UNITED STATES OF AMERICA
NUCLEAR REGULATORY COMMISSION

In the Matter of	)	
	)	
U.S. DEPARTMENT OF ENERGY	)	**Docket No. 63-001**
	)	
(High Level Waste Repository)	)	**December 19, 2008**

STATE OF NEVADA'S
PETITION TO INTERVENE AS A FULL PARTY

Figure 4.2-2. Annual Frequency of Intersection of Any Feature with the Repository Footprint: Aggregate and Individual Cumulative Probability Results for the 10,000-Year Assessment

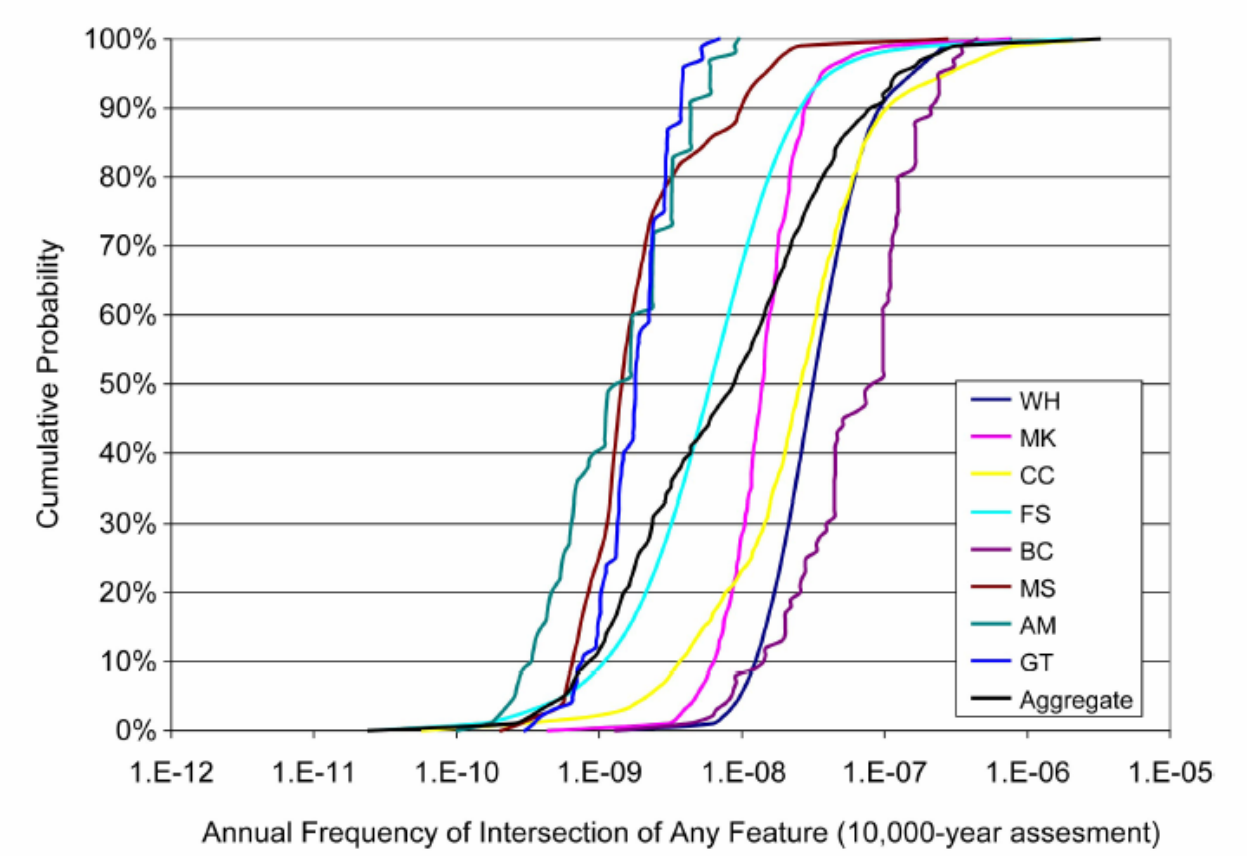
To show that the different methods of aggregation yield different results, an example of application of the three alternative methods is given below. First, the following figure, which is

taken from PVHA-U at 4-115, shows cumulative probability distributions elicited from eight experts along with an aggregate distribution. The latter was calculated, using equal weights for the experts, by averaging vertically, i.e., for each value on the horizontal axis, the values vertically above were averaged. This is "probability averaging," and the resulting aggregate distribution represents the spread of opinion among the eight experts. It is shown by the black line, which cuts across the other eight cumulative distributions, so the variance is larger than any
